**PIBLINELL CARBON DEUOCSID HYNET ARFAETHEDIG / PROPOSED HYNET
CARBON DIOXIDE PIPELINE**

RE: NATURAL RESOURCES WALES' DEADLINE 6 SUBMISSION

ANNEX A: Hydrogeological Impact Appraisal of Open Cut crossing, Alltami Brook [REP5-014]

Figure 1: Additional boreholes at the Alltami Brook crossing location

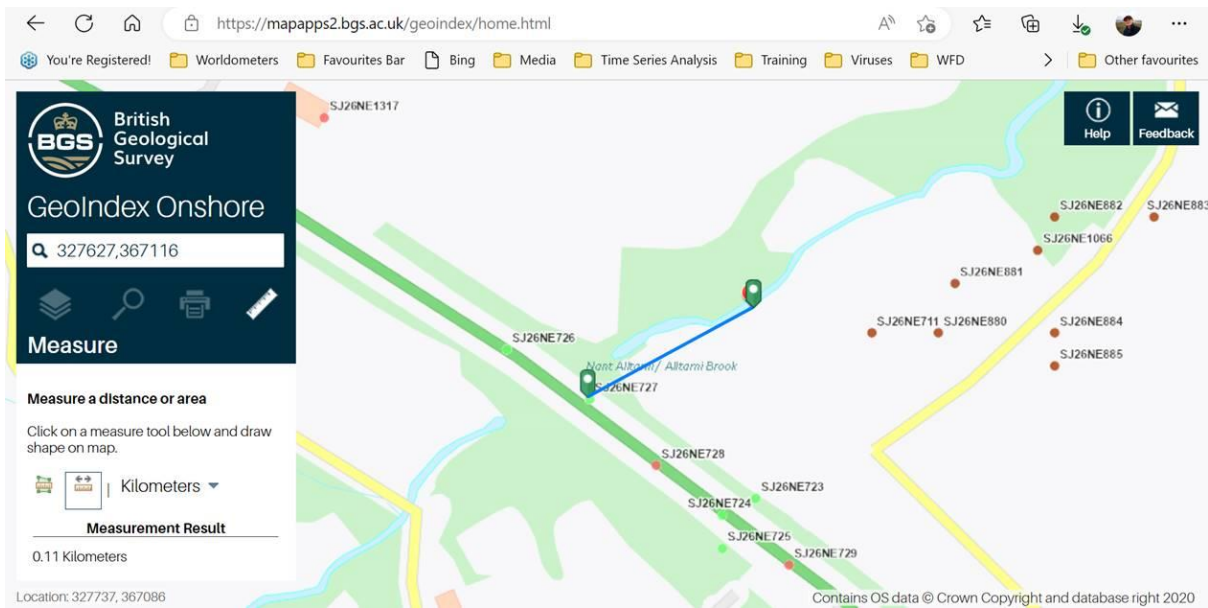
- 1.5 Table 2.2 of the HIA presents information from four boreholes located along the A55 in proximity to the proposed Alltami Brook crossing point. NRW's review of the British Geological Survey's (BGS) GeolIndex shows the presence of other boreholes in the vicinity and their respective borehole logs which have not been considered in the HIA. These boreholes are shown on Figure 1 below, which also includes the approximate distance from the A55 to the proposed Alltami Brook crossing point. The information from the full complement of boreholes reveals that groundwater may not be present, and where it is found to be present the depths to which it is encountered vary. The information from the boreholes presented in the HIA is therefore not considered to be comparable or to provide a sense of continuity in the hydrogeological regime in the locale of the Alltami Brook crossing point. In addition, the boreholes presented in the HIA are installed within different geological units in comparison to the geological units within which the proposed pipeline would be installed, *i.e.*, an 'isolated younger outcrop of Pennine Lower Coal Measures mudstone, siltstone and sandstone surrounded by the older Gwespyr sandstone (see Figure 3 below).

Figure 2: BGS 1:10,000 map excerpt for the proposed Alltami Brook crossing location

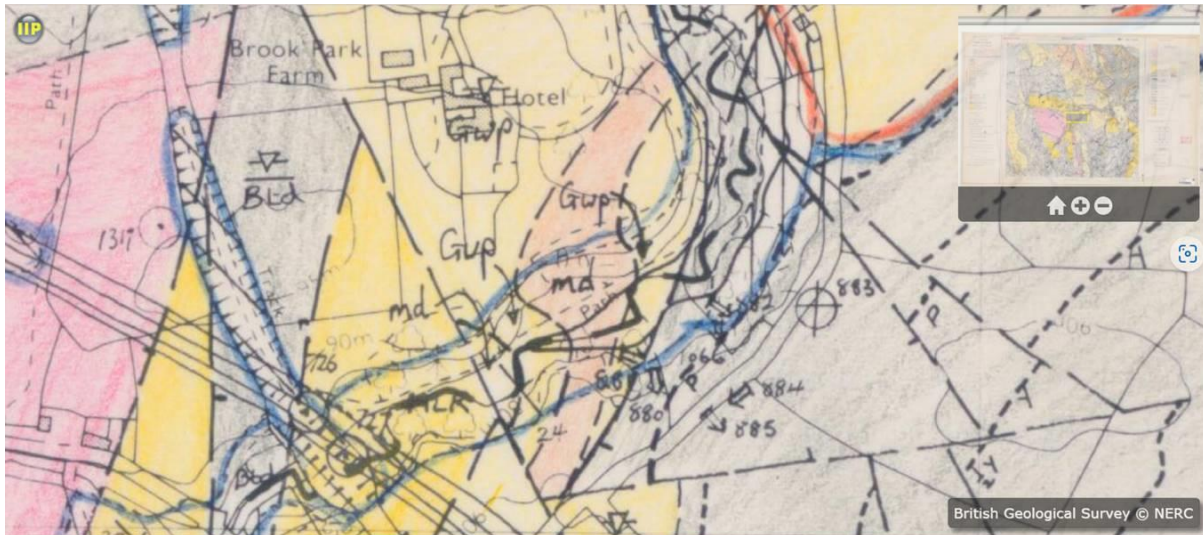
1.6 The BGS 1:10,000 map excerpt (Figure 2 below) shows the disc-like boundary outline (outlier) of the Lower Coal Measures Unit (md) with the Gwespyr sandstone (Gwp) to the east and a NE to SW trending fault to the west, demarcating the outlier within which the pipeline is proposed to be installed. Figure 2 (below) shows a number of faults, one of which is located between the crossing point and the particular boreholes on the A55 that have been presented within Table 2.2 of the HIA. Therefore, in the absence of any site-specific ground investigation data, it is not considered possible to be certain that there is groundwater connectivity between the groundwater encountered in the boreholes along the A55 and the proposed crossing point. Rather, the fault could function as a hydraulic barrier to flow and the particular outcrop of the lower Coal Measures and Gwespyr sandstone at the crossing point could be unsaturated bedrock. It is possible that any groundwater contribution to the Alltami Brook in the crossing-point locale is inconsistent in its nature, *i.e.*, in some locations there may be contribution and in other locations it may be completely absent. Any groundwater contribution will largely be controlled by the presence of transmissive fractures, if present, the influence of faults in terms of helping or hindering groundwater flow and lithological control.

- 1.7 Furthermore, Borehole SJ26NE727 presented in Figure 2.2 and Table 2.2 of the HIA states that the well was drilled to 15.1m which yields a borehole base elevation of 64.4m AOD. This is below the proposed Alltami Brook crossing point elevation which is ~73m AOD: as the excavation is approximately 4m deep this gives an excavation elevation of ~69m AOD. The borehole log describes fluid loss at 4.5m depth yet encountering groundwater at 14.3m (i.e., below the level of Alltami Brook), although this rises to +0.3m due to pressure. We also note that there are two largely dry boreholes located along the A55, drilled to a greater depth of 40m (Boreholes SJ26NE728 and SJ26NE729). It is possible that Borehole SJ26NE727 encountered a transmissive fracture at depth whereas Boreholes SJ26NE728 and SJ26NE729 did not. This highlights the lack of consistency in the ground materials and groundwater conditions at the site. In our view, it is therefore not possible to rely upon the information from any one borehole regarding the potential contribution of bedrock groundwater levels to the Alltami Brook, as the information is inconsistent between them. In addition, the geology encountered along the A55 is of a different time period in comparison to the expected geology at the Alltami Brook crossing and is separated from the geology at the crossing point by a fault.

Figure 3: the relationship of the proposed Alltami Brook crossing point to the seepage reported in the HIA (para 2.7.9).

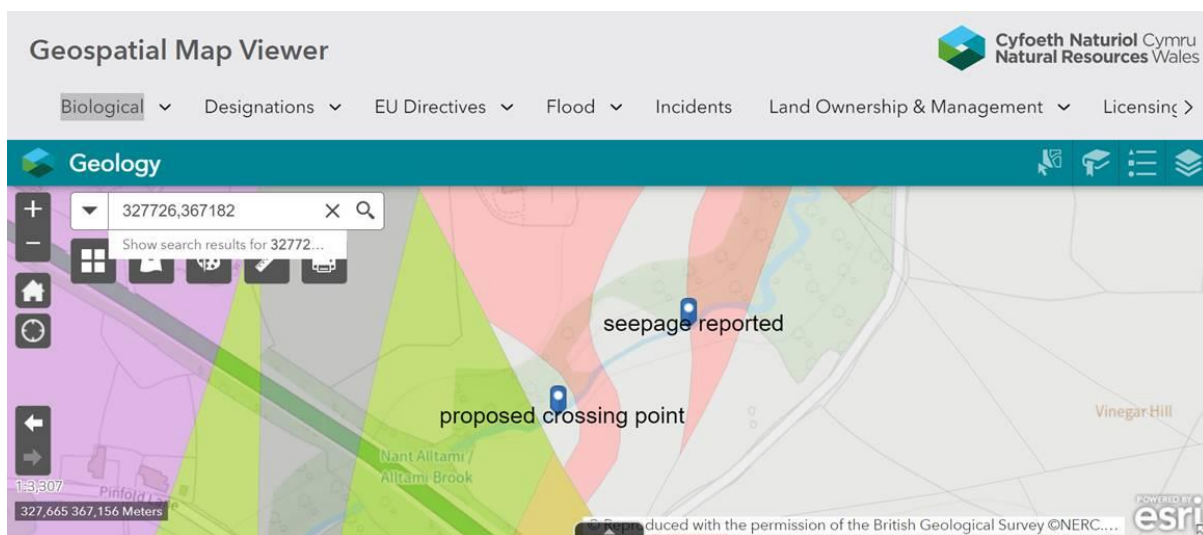
- 1.8 The following excerpt (Figure 3 below) is from the NRW Geospatial Map viewer and shows the relationship of the proposed Alltami Brook crossing point to the seepage reported in the HIA (para. 2.7.9); it has been drafted using coordinates presented by the Applicant. Based on the mapping shown in Figure 3 below the seepage appears to be a contact seepage between the two different coloured units (designated as pink and grey in Figure 3) so may not be a fracture flow contribution, as hypothesised by the Applicant, but rather a manifestation of the permeability difference between where sandstone and mudstone contact each other, for example. This seepage point is approximately 120m downstream from the proposed crossing point and is at a lower elevation. The estimated crossing point elevation is ~73m AOD.

- 1.9 The seepage is therefore not considered reconcilable to the crossing point itself because the fault that is immediately upgradient of the crossing point may hinder groundwater flow in the bedrock. It is unlikely that there is consistent

contribution of bedrock groundwater flow along the reach of Alltami Brook because such contribution would require a consistent network of saturated and transmissive fractures to intersect Alltami Brook. Figure 3.1 of the HIA (Preliminary Hydrogeological Conceptual Model) would suggest that such a consistent and spatially extensive network of saturated and transmissive fractures exists, which is unlikely to be the case as the borehole logs suggest, coupled with the possibility that local faulting hinders the continuity of groundwater flow.

Figure 2: Compound 31A

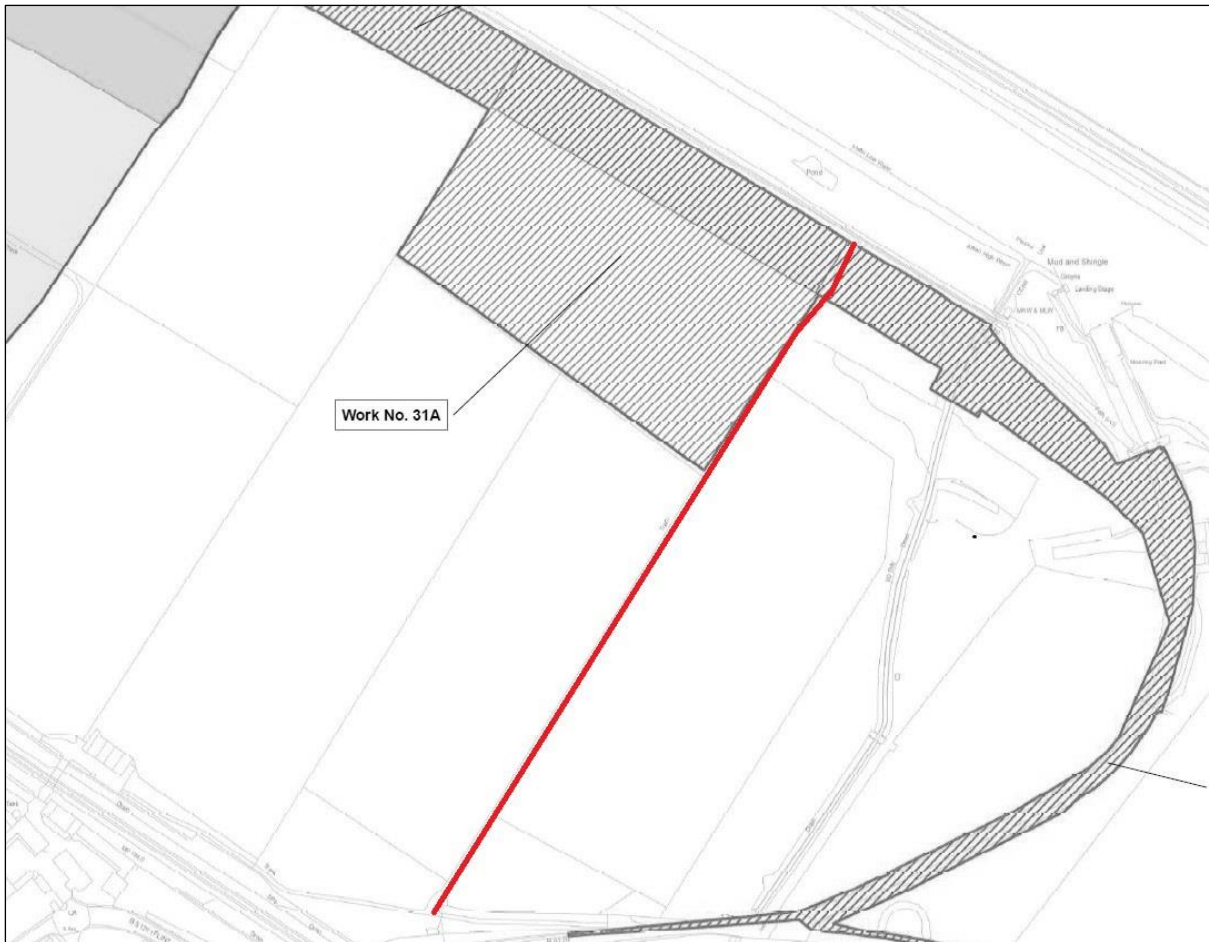
The red line above shows NRW's only access point to the Hawarden Embankment at this location. It needs to be ensured that there are adequate access provisions for an excavator with flail to get on to the crest of the embankment. There are also key flood risk structures here (Beeches Drain outfall) that can only be accessed at this point.

It needs to be ensured that the compound layout does not prohibit access and any fencing is adequately offset from the access track so that this remains free from any obstructions.
